STAFF REPORT 7-24-2019 MEETING
APPLICATION NUMBER 19-6346
ADDRESS: 3475 IROQUOIS
HISTORIC DISTRICT: INDIAN VILLAGE
APPLICANT: BEN CARBURY
DATE OF STAFF VISIT:

PREPARED BY: J. ROSS

3457 Iroquois Exterior Work: (A) Front Porch/ (B) Back Porch/ (C) Landscaping/ (D) Soffits, fascia, Gutters, (E) driveway, (F) garage, (G) Glassblock

EL-1

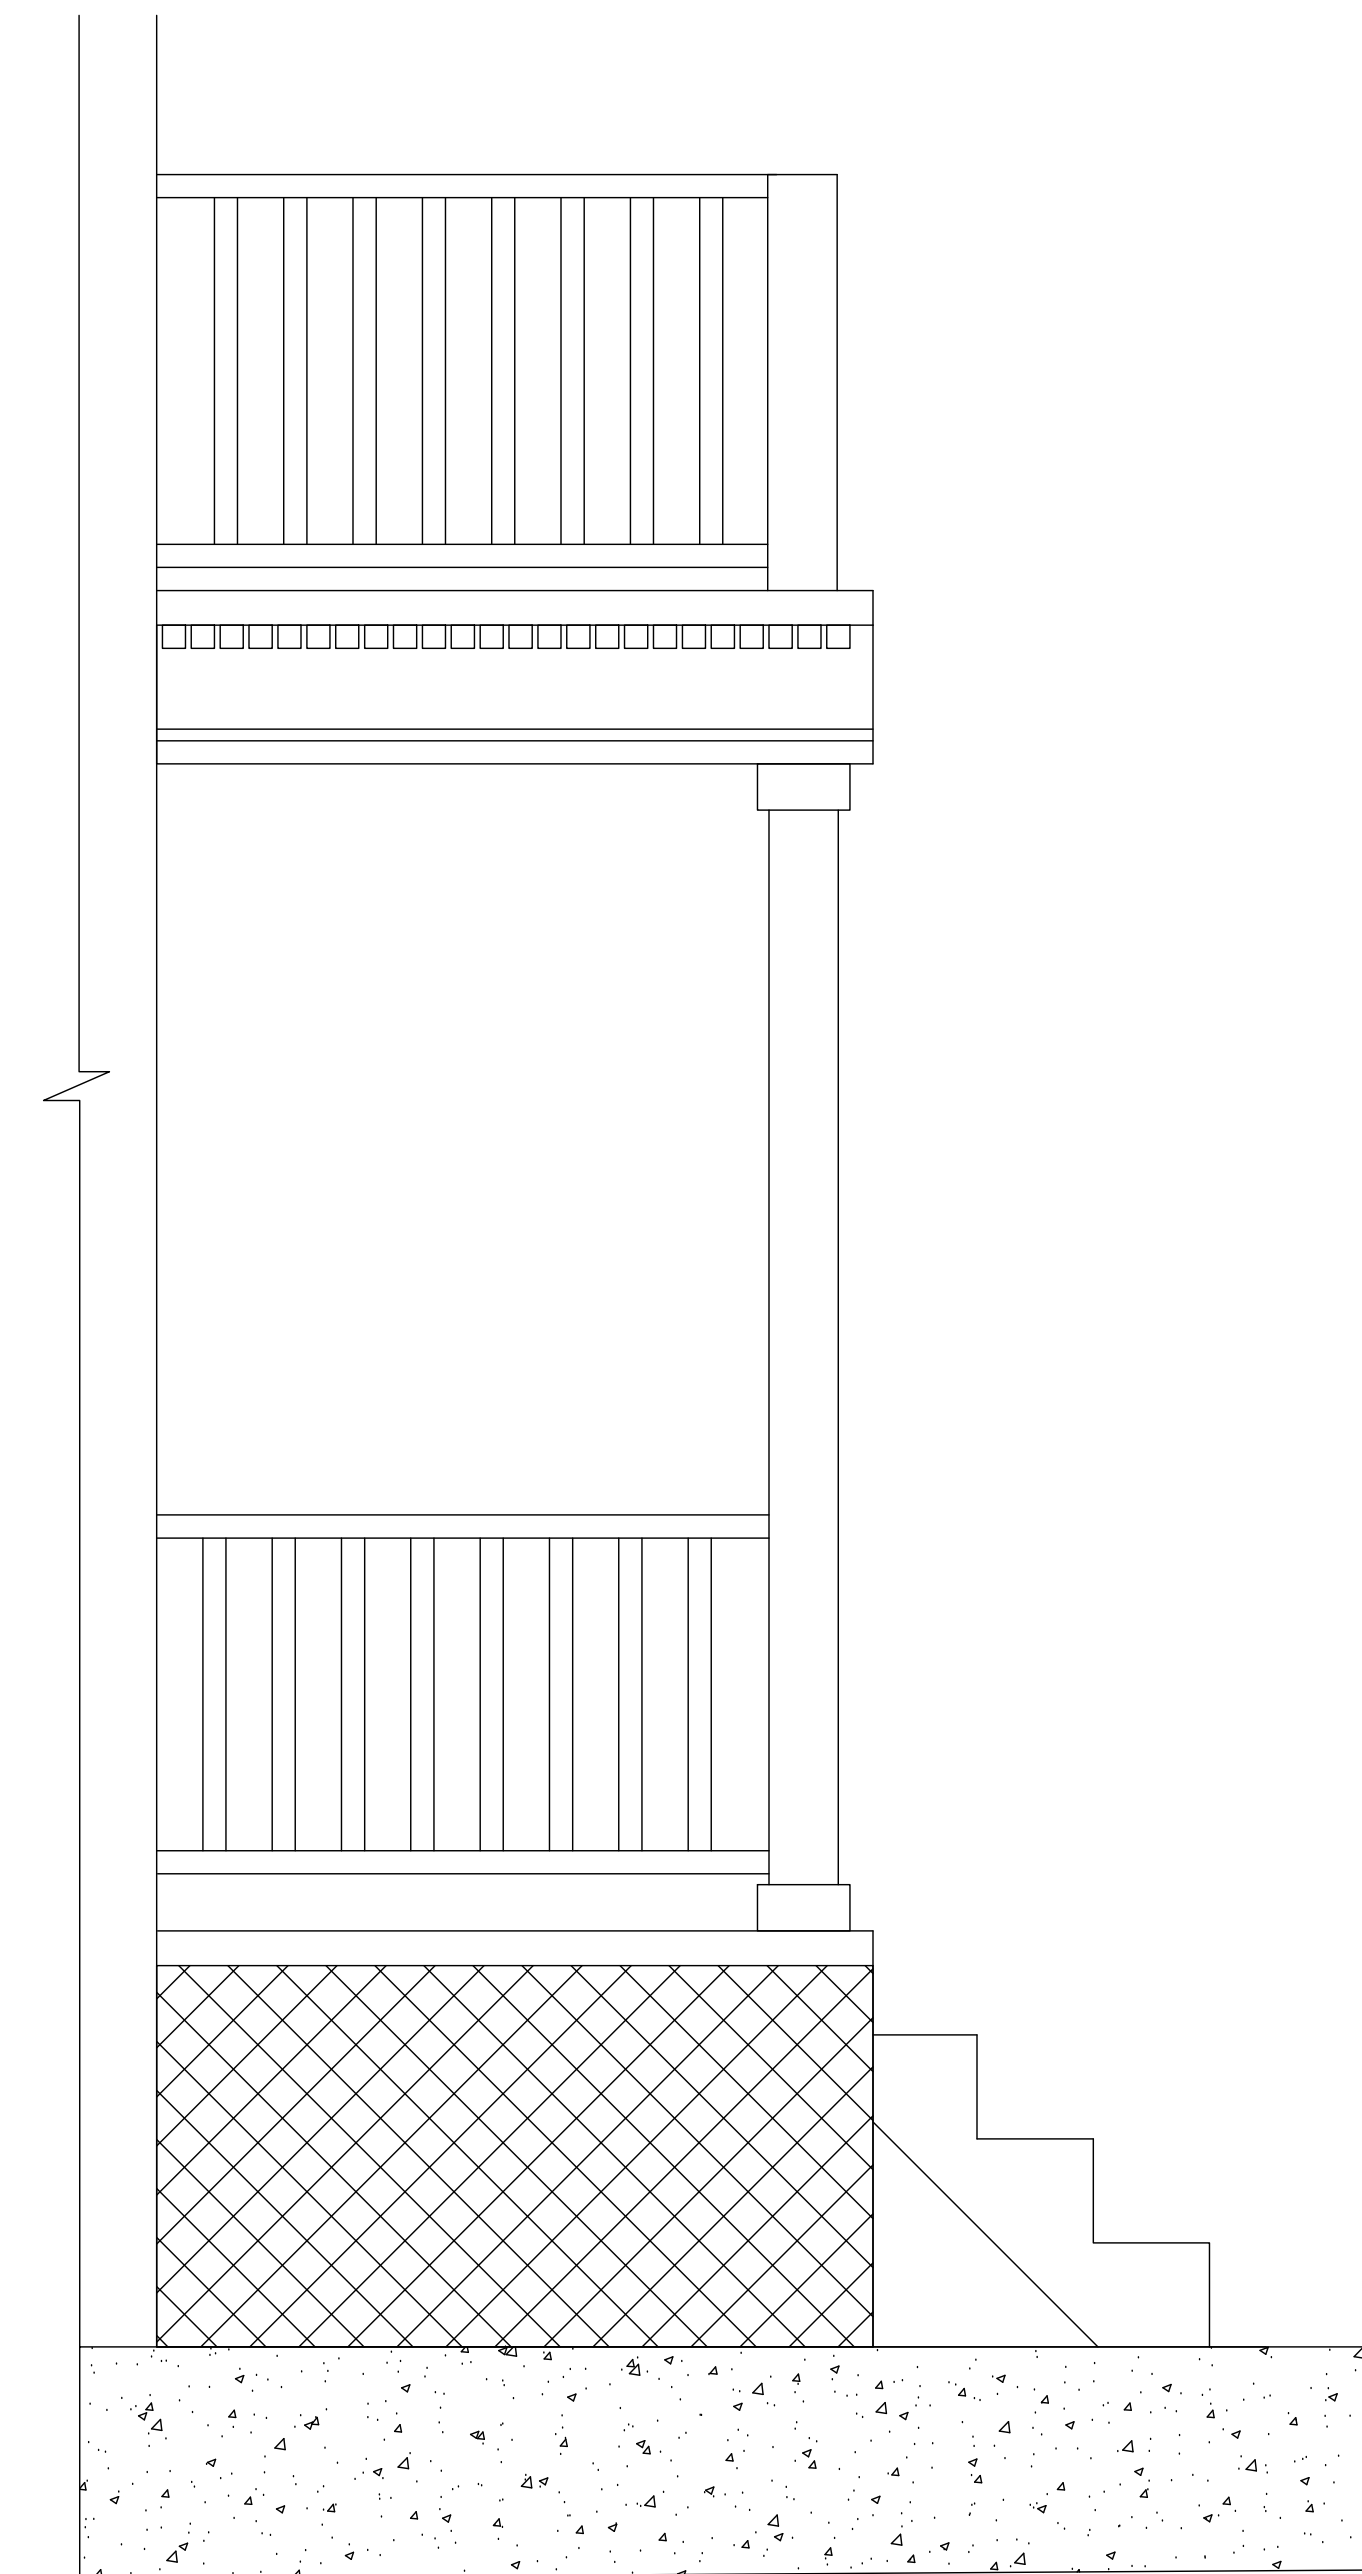
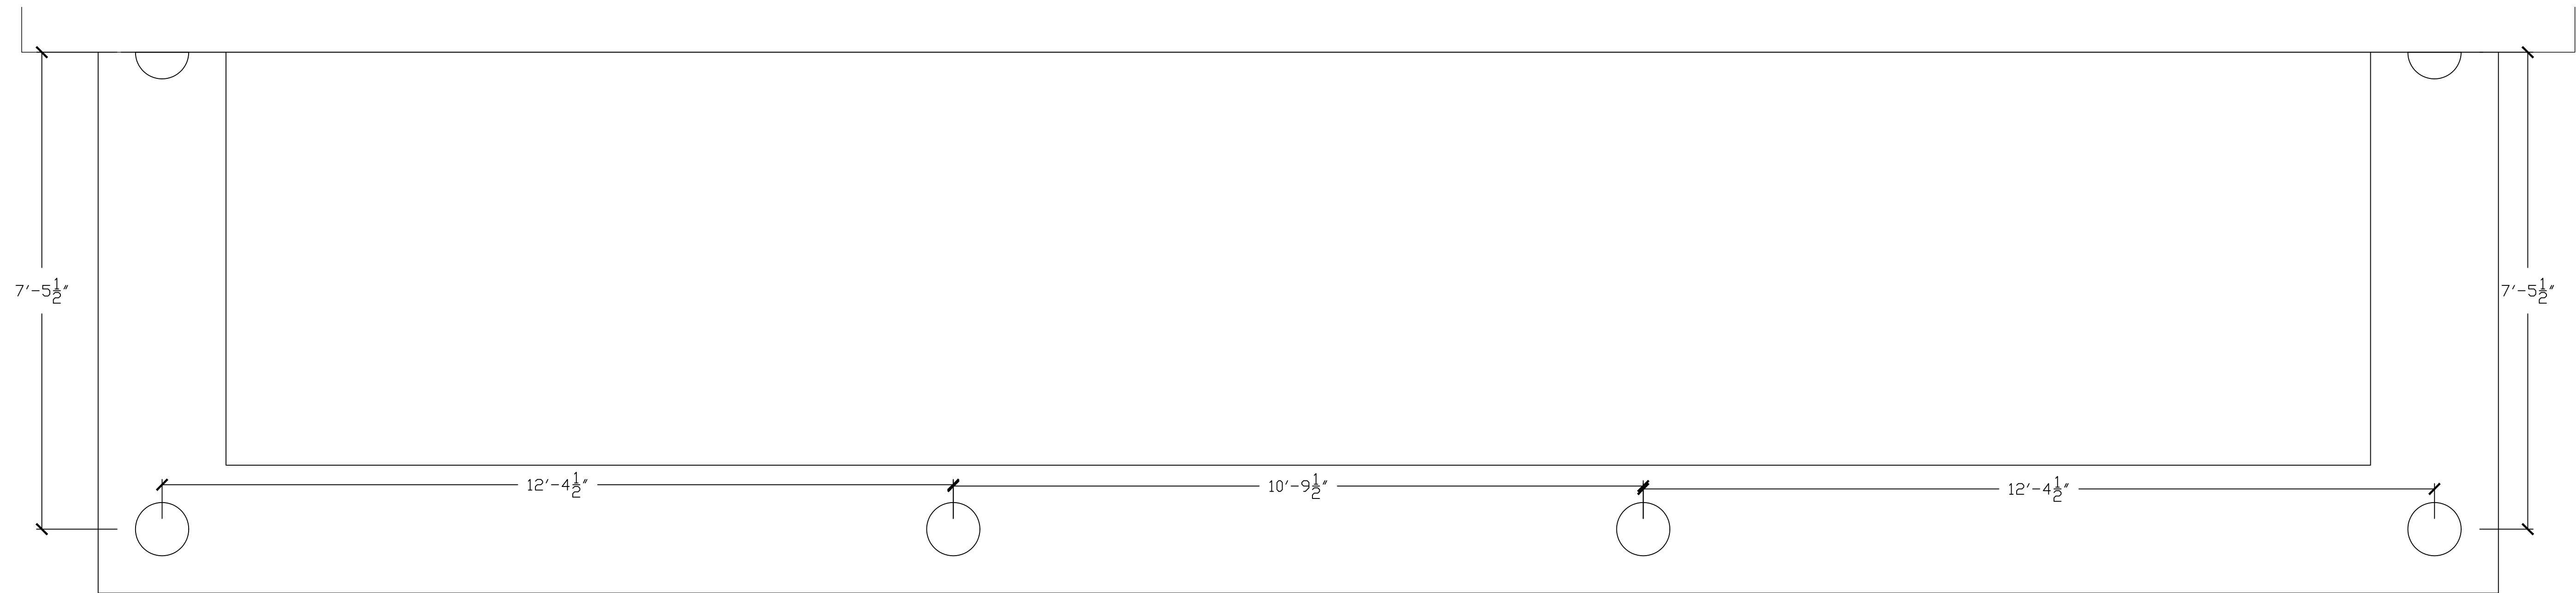
In regard to the front porch proposal, the applicant has stated that he plans on to rebuilding the front porch to match the original design. However, the submitted drawings are not dimensioned and do not provide drawings which indicate that the original porch details will be exactly replicated. Also, although the proposed new rear porch generally appears to be appropriate, the submission does not provide dimensions for the section of the porch, nor does it provide a rear elevation drawing which indicates where the new will be installed. Staff therefore recommends that the Commission issue COA work proposed at the front and rear porches because they meet the Secretary of the Interior's Standards for Rehabilitation, standards # 6) *Deteriorated historic features shall be repaired rather than replaced. Where the severity of deterioration requires replacement of a distinctive feature, the new feature shall match the old in design, color, texture, and other visual qualities and, where possible, materials. Replacement of missing features shall be substantiated by documentary, physical, or pictorial evidence.* However, staff does recommend that the Commission issue this approval with the following conditions:

- The applicant shall retain the two remaining wood pilasters at the front elevation.
- The applicant shall provide HDC staff a **dimensioned elevation drawing** which depicts the building's front elevation; the existing wood pilasters, brick walls, and concrete steps; and the proposed new columns, cornice, and roof prior to the issuance of the project COA. HDC Staff shall be afforded the opportunity to review and approve the new dimensioned elevation drawing prior to the issuance of the project COA. If HDC staff determines that any of the new porch elements ***do not exactly replicate the historic porch***, staff shall forward the porch proposal to the commission for review at a future meeting.

- The applicant shall provide drawings to HDC staff which indicate that the original front porch cornice and columns will be exactly replicated in material, dimension, style/type, and detailing prior to the issuance of the project COA. HDC Staff shall be afforded the opportunity to review and approve the new detail drawings. If HDC staff determines that any of these new elements ***do not exactly replicate the historic porch***, staff shall forward the porch proposal to the Commission for review at a future meeting.

Compact Three Car Garage Plan #600-2C

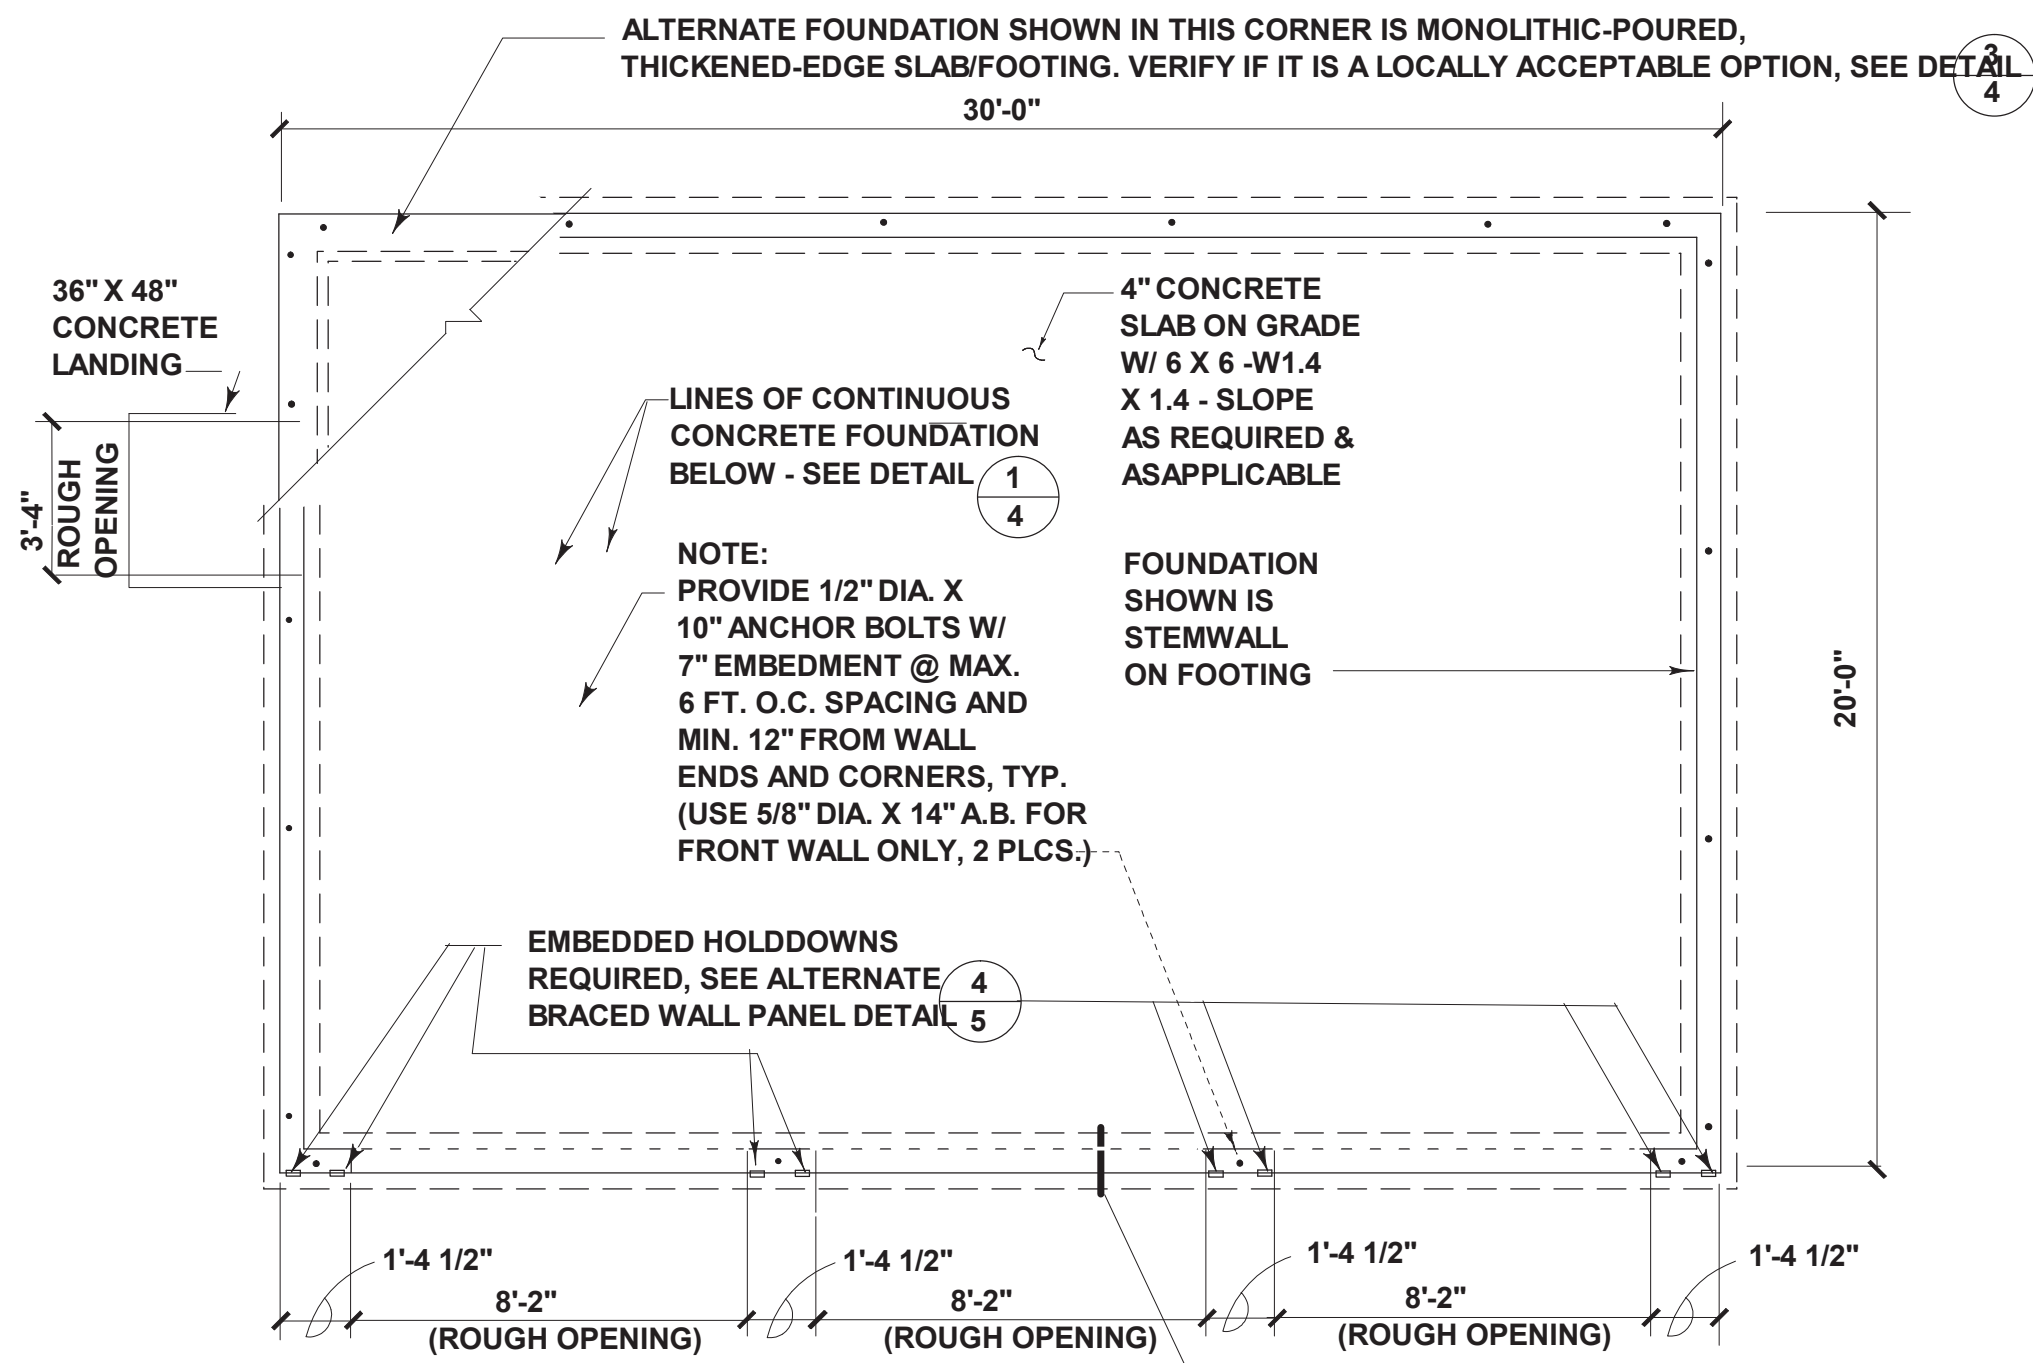
In regard to the proposed new 3-car garage, note that it is located well to the rear of the home and will be minimally visible from the public right-of-way. It is staff's opinion that the proposed new building is generally compatible with the existing historic home. However, staff does question the durability/lifespan of the proposed textured OSB siding/cladding.

- The garage shall be clad with lapped composite/Hardi siding with a smooth finish/texture.
- The color of the new garage's exterior doors and windows shall be Yellowish White, to match building's the trim color
- The applicant shall provide HDC staff the dimensions of the existing hardscape and the proposed new/replacement hardscape (driveway approach, ribbon driveway, and rear yard parking apron) so that they might verify that the new will replicate the old/existing prior to the issuance of the COA. If the application proposes to expand the existing hardscape footprint, HDC staff shall forward this portion of the proposal to the Commission for review at a future meeting.
- The garage windows shall be aluminum or aluminum-clad wood units
